SHD0009/22 White Heather Industrial Estate, South Circular Road, Dublin 8 and 307/307a South Circular Road and 12a St James's Terrace, Dublin 8.

Comments by DCC Parks, Biodiversity & Landscape Services

May 23rd 2022

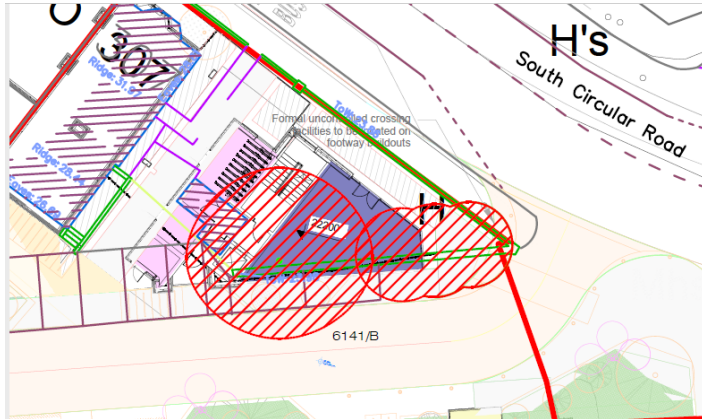
The public open space (POS) provision requirement is 10% of the site area or 1535m² and the stated provision is 2960m² in 3 areas yellow and pink as below. The area calculation plan seems to include required buffer strips to private buildings which should have been excluded.

It is advisable that a public right of way is established from the South Circular Road to connect to the proposed public open spaces, as indicated with red-dashed arrow above to ensure public access.
